D1 Accommodation

REVISED PROPOSALS

The planning application drawings showed a proposal to increase the depth of oversail and lower the height of the passageway at Clarendon Grove. These proposals were not welcomed by the officer and the team have subsequently considered amendments to improve the design.

Revised Ground Floor Plan

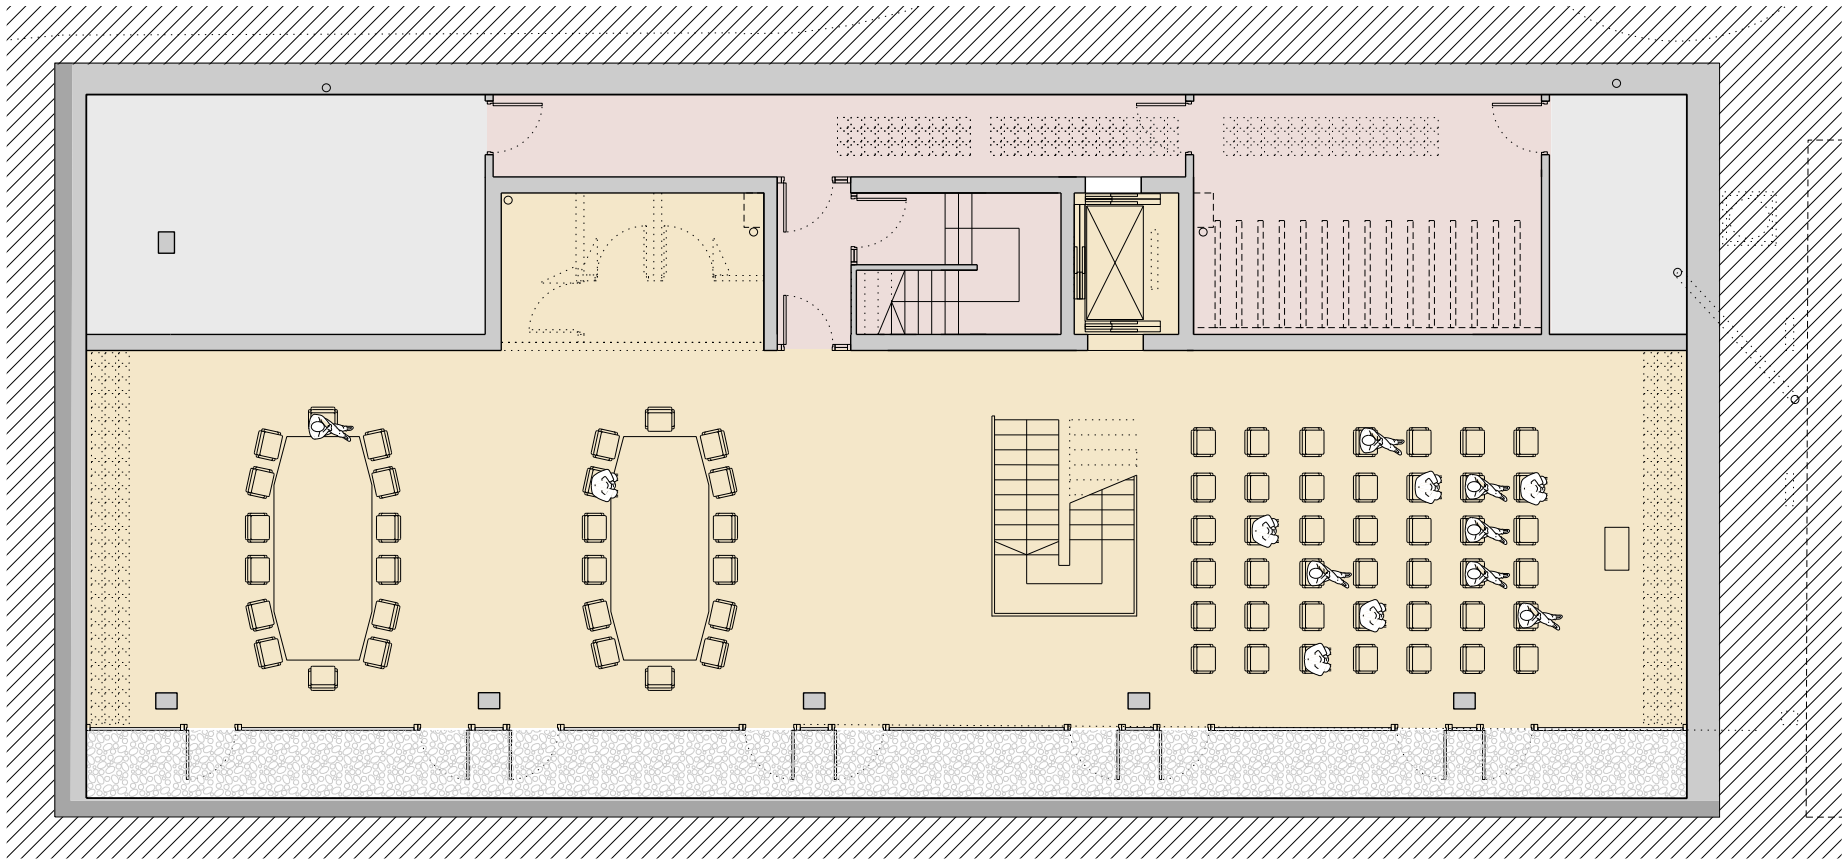
- Removed the need for the second row of columns which previously interrupted the usable floor space at ground and basement level. An increase of 25mm in slab thickness will allow the floor to span onto the wall which aligns with the stair core. This in turn frees up the area to accommodate uses requiring a more open plan arrangement such as lectures, exhibitions, group meetings and gatherings.

- The position of the D1 accommodation stair could be moved to allow for a connecting entrance lobby at ground floor if required by the end user. This will allow users to move freely between the two D1 spaces at ground floor without leaving the building.

- The floor to ceiling height at ground floor level has been increased from 2.9m to 3.425m to allow for a range of uses to take place, including use of a ceiling mounted projector.

Cross Section - Revised heights and columns removed

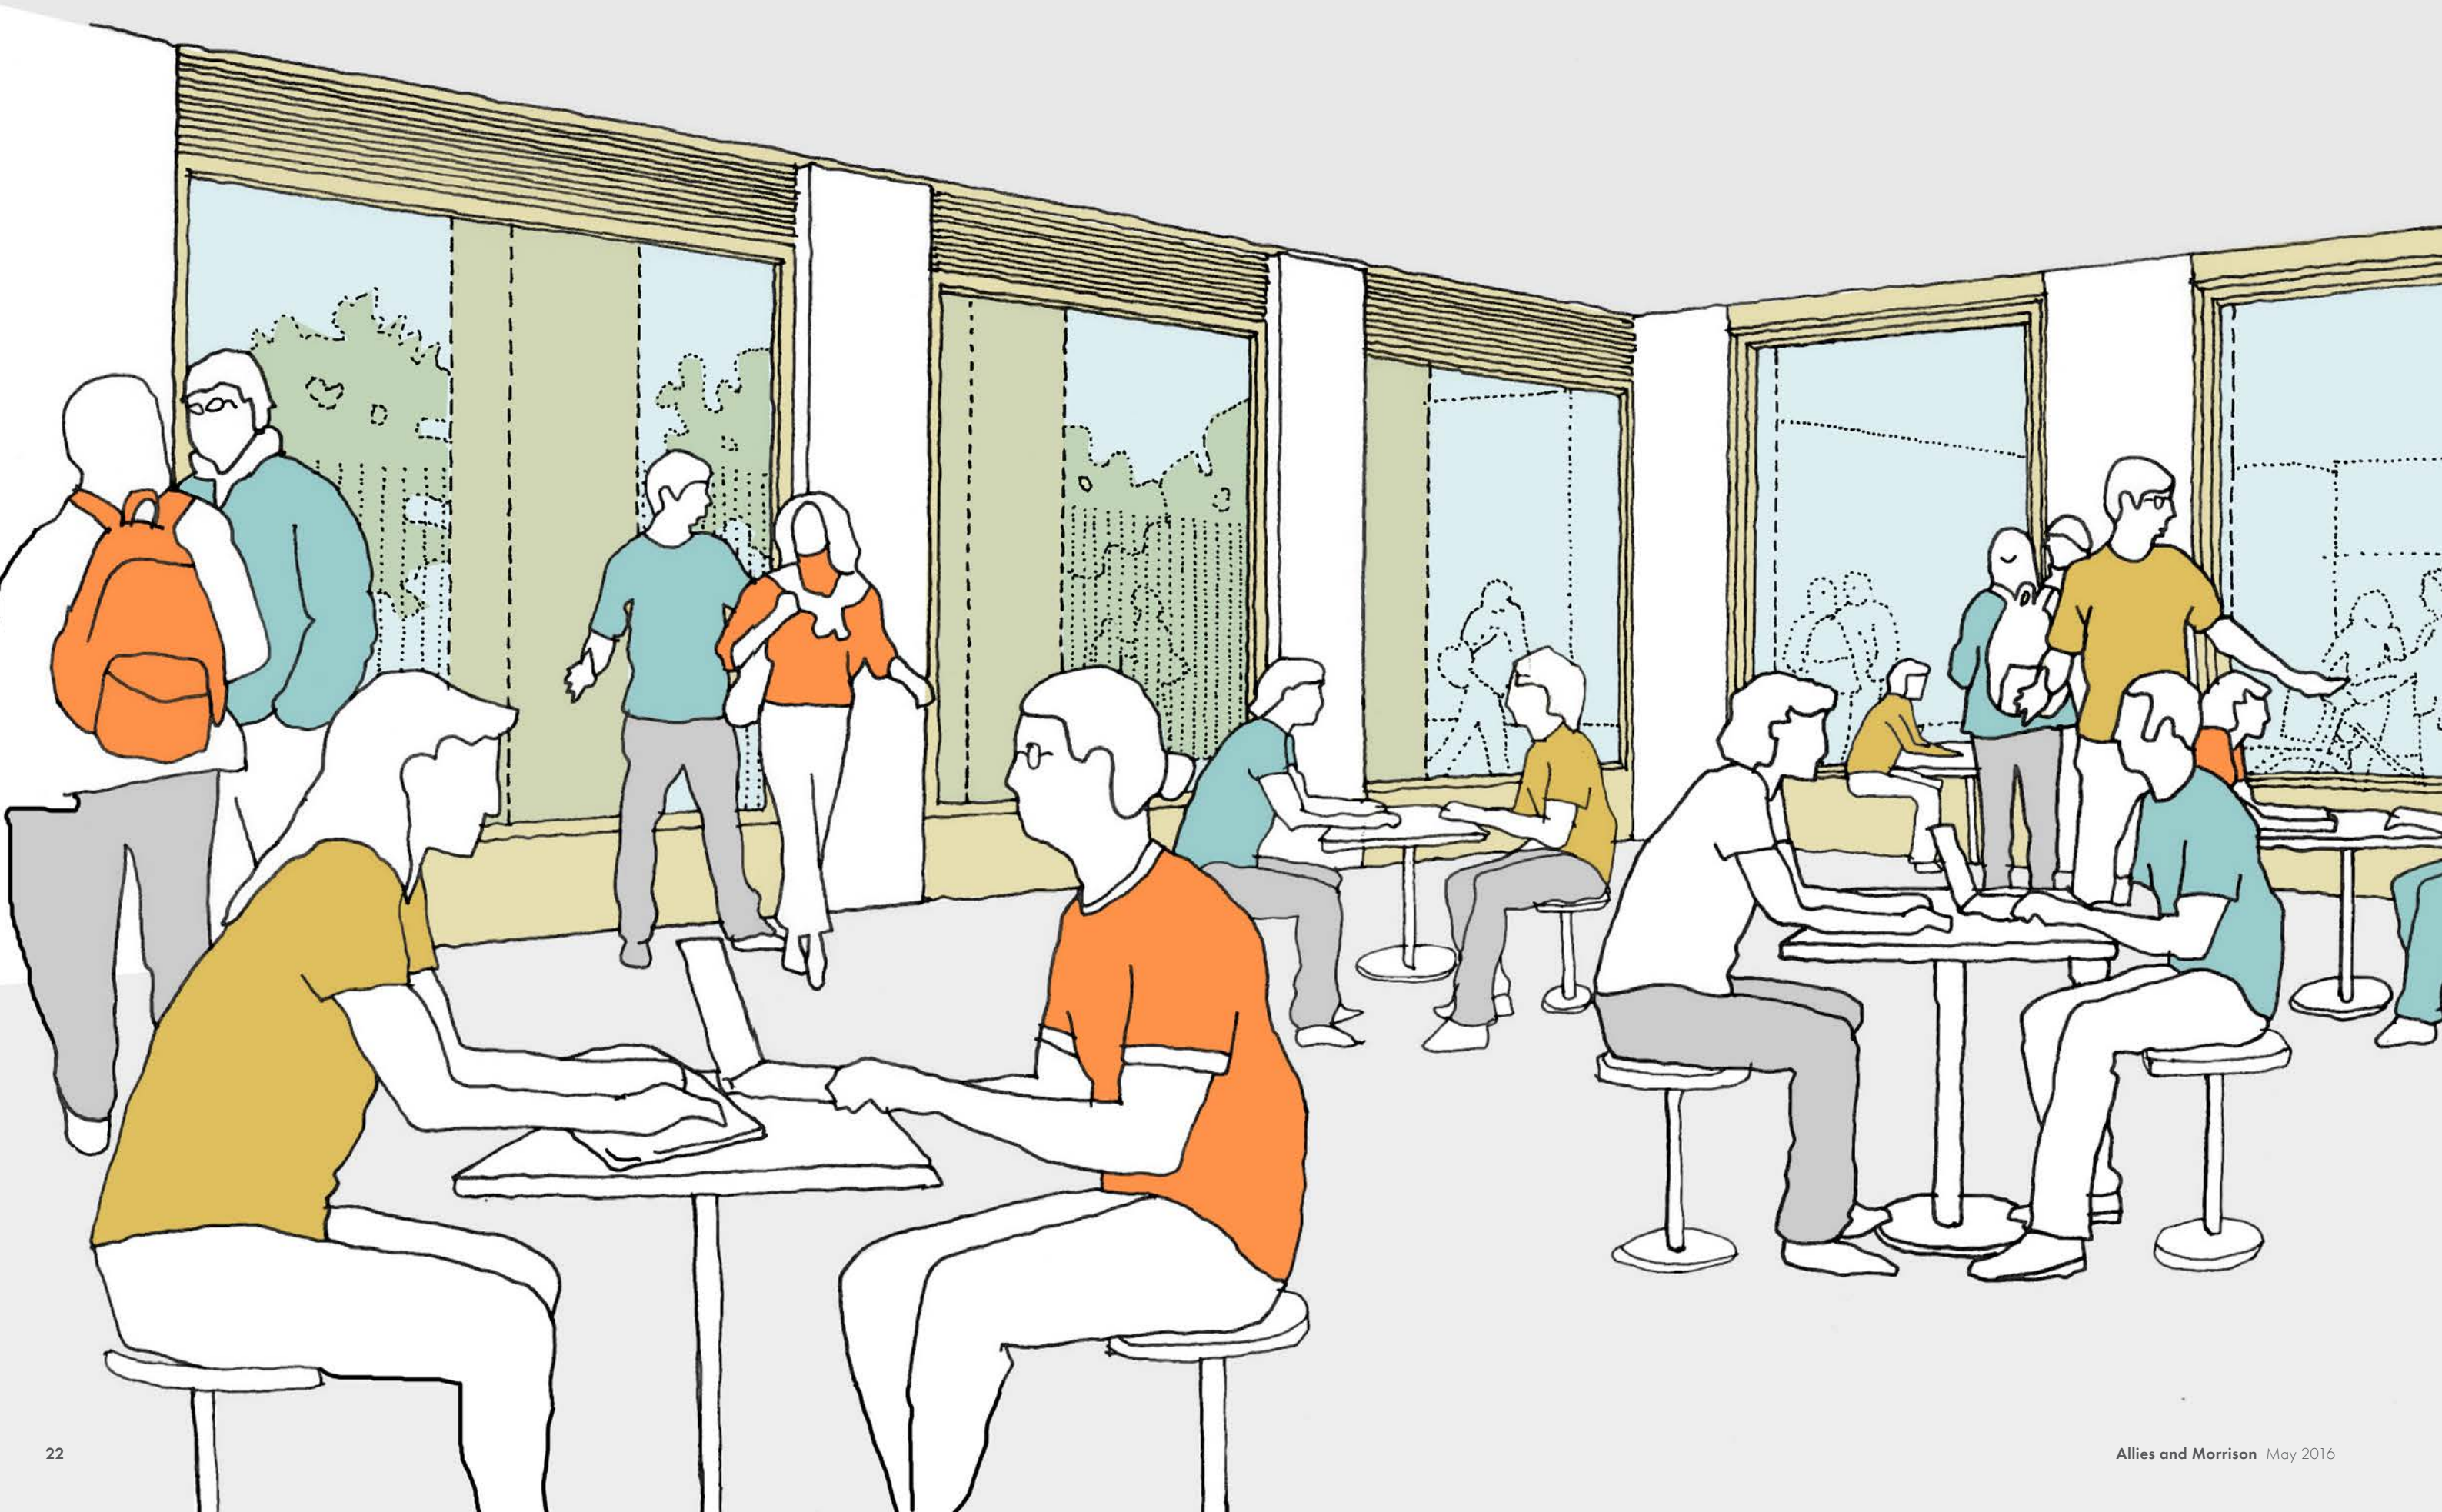
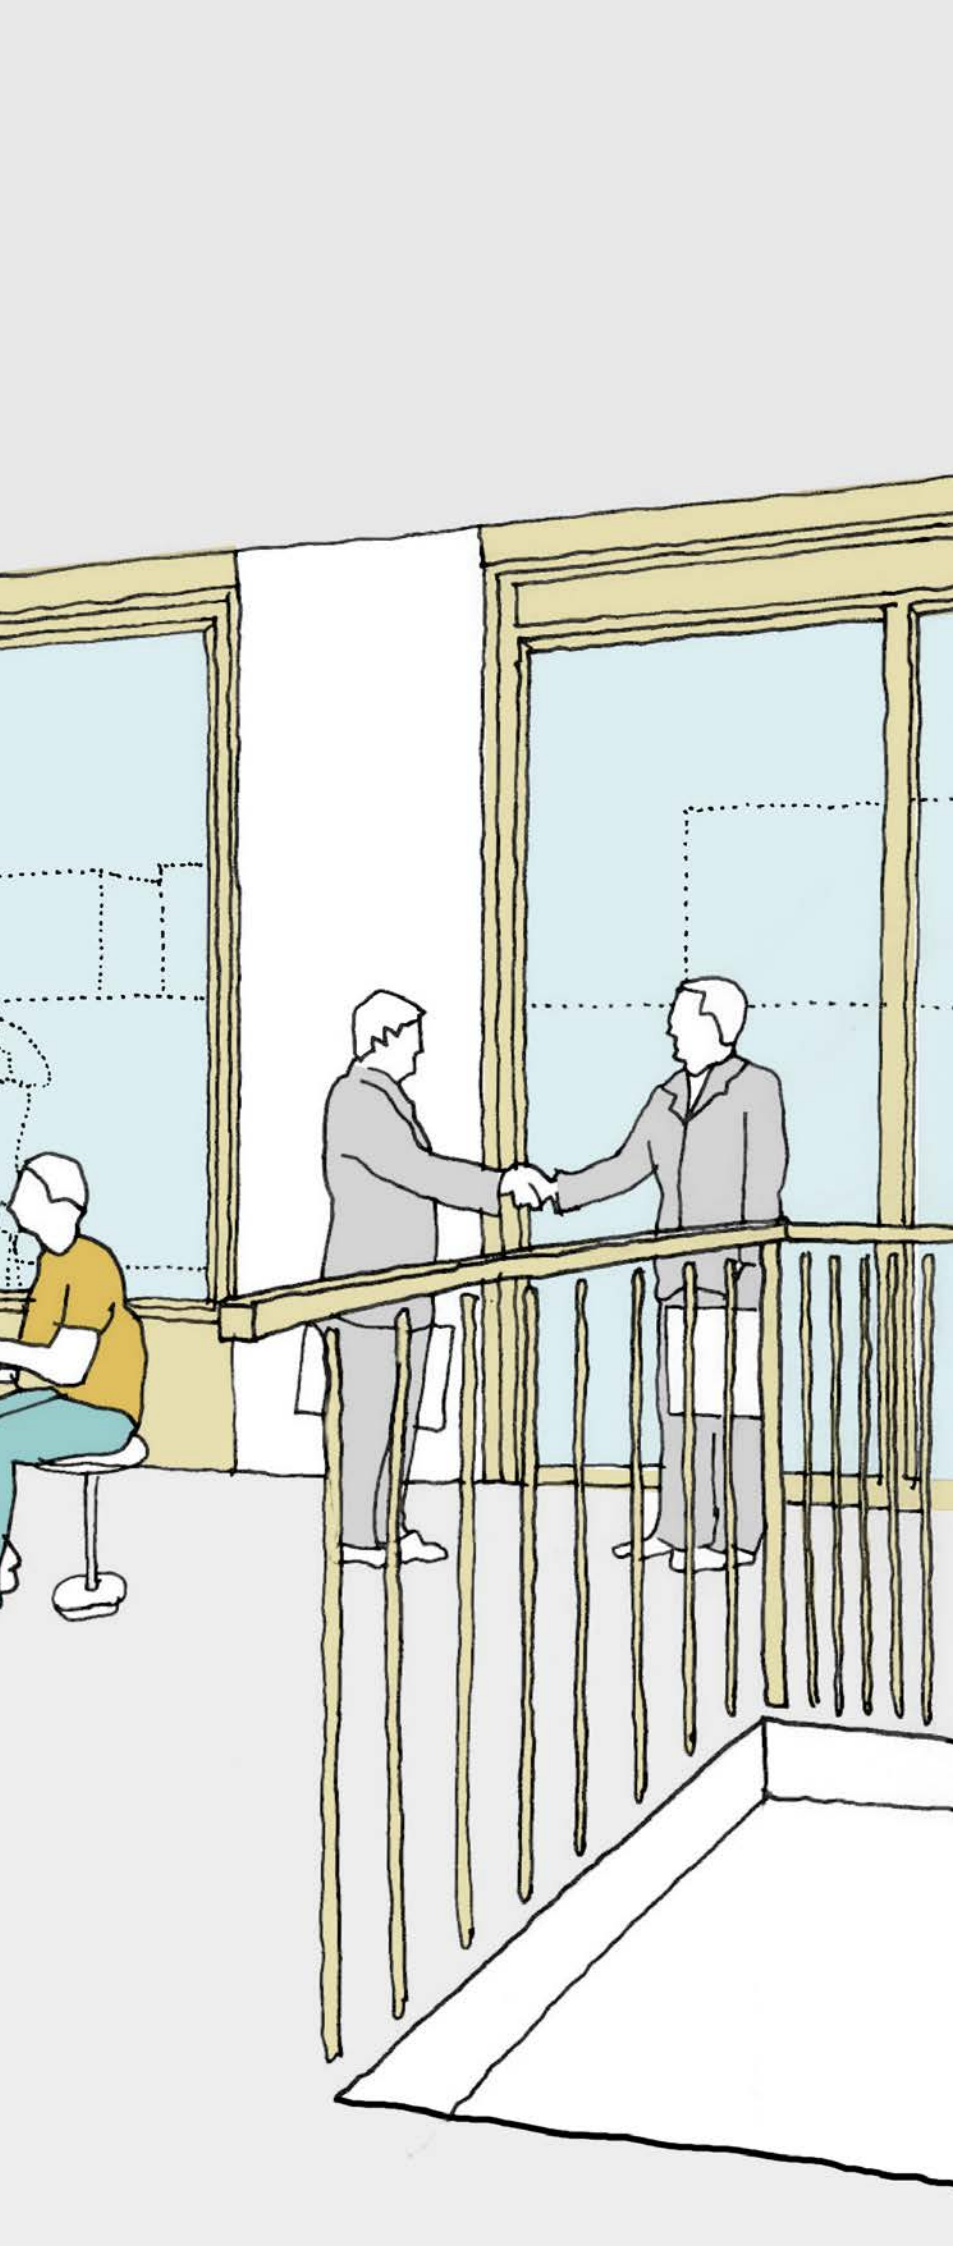
- The floor to ceiling height in the basement will be increased from 2.67m to 2.8m which, will be more than sufficient for most uses. (The team undertook a study and results showed that we could not increase the basement height as much as the ground floor as the floor level of the basement is constrained by drainage invert levels for gravity surface water drainage. Pumping surface water drainage is not a consideration as there is insufficient space in the building for the emergency storage requirements.)

1.8m gap

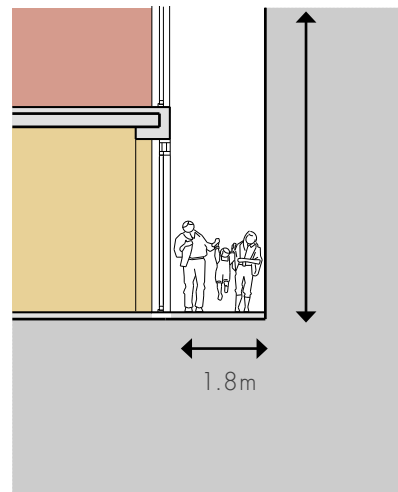
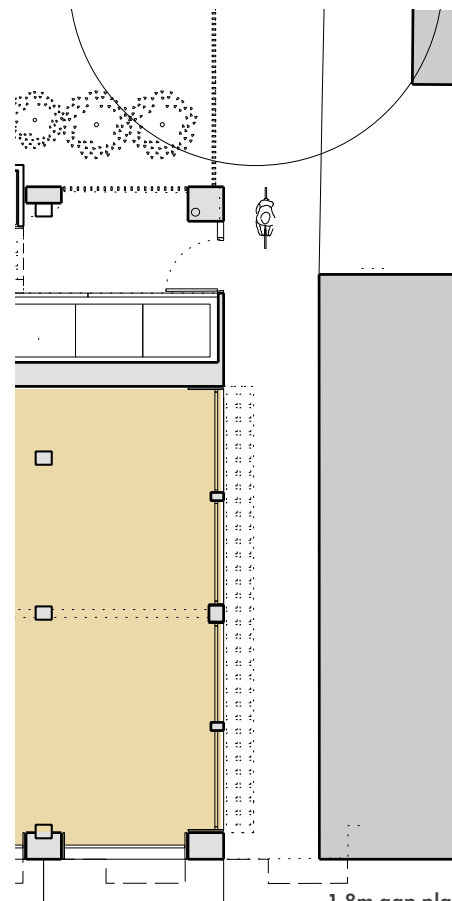
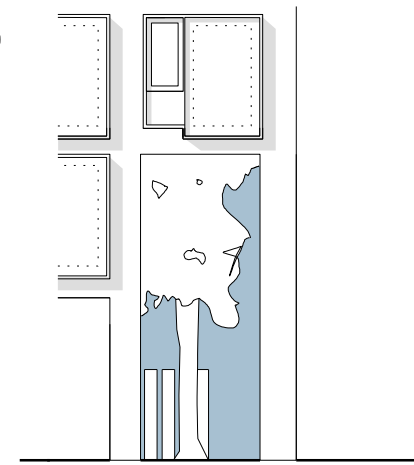
Advice from officers is that the existing oversail should be removed and the existing 1.8m gap should be open to the sky.

Camden have suggested that the proposed new building should no longer oversail Clarendon Grove, but should instead leave the existing 1.8m walkway, fully open to the sky, between the existing building and the Maria Fidelis school.

We believe that the resultant full-height narrow slot between buildings would not contribute positively to the use of the route in terms of quality, safety or security. In townscape terms the route would remain uninviting and discrete.

As proposed

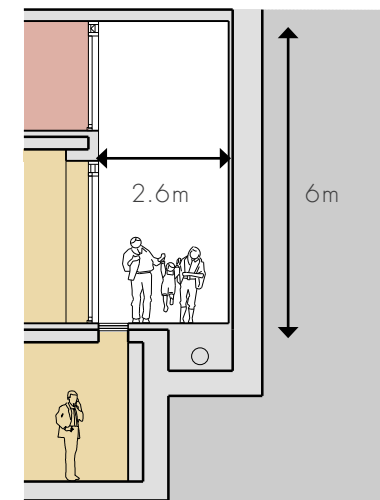
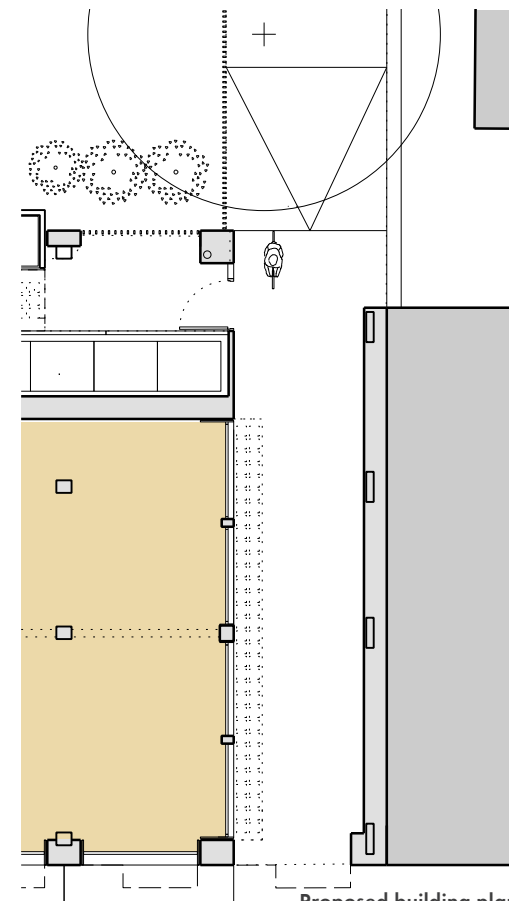
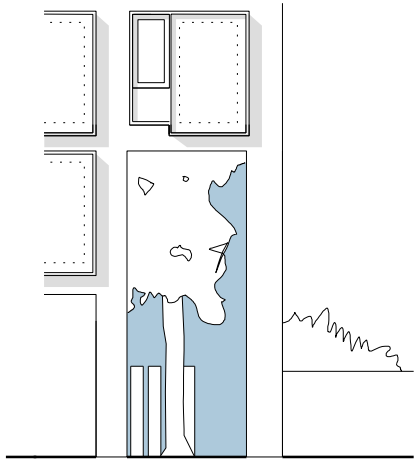
We propose to increase the height of the passageway to two storeys tall (6m) and 2.6m in width.

As an alternative solution, within this amendment to the planning application we proposed to increase the height of the passageway, making it two storeys with a loss of two bedrooms on the first floor apartment, thus reducing the overall bedrooms from 55 to 53.

We have retained the increased clear width of 2.6m (with a 2.15m wide threshold at either end to allow for the 4 brick wide piers on the north and south elevation). The height is increased from 2.7m in the previous proposal to 6m clear - a 3.3m increase which will bring in more daylight but also sets a hierarchy on the elevation and marks a threshold into this route. There are many successful references for this approach across London.
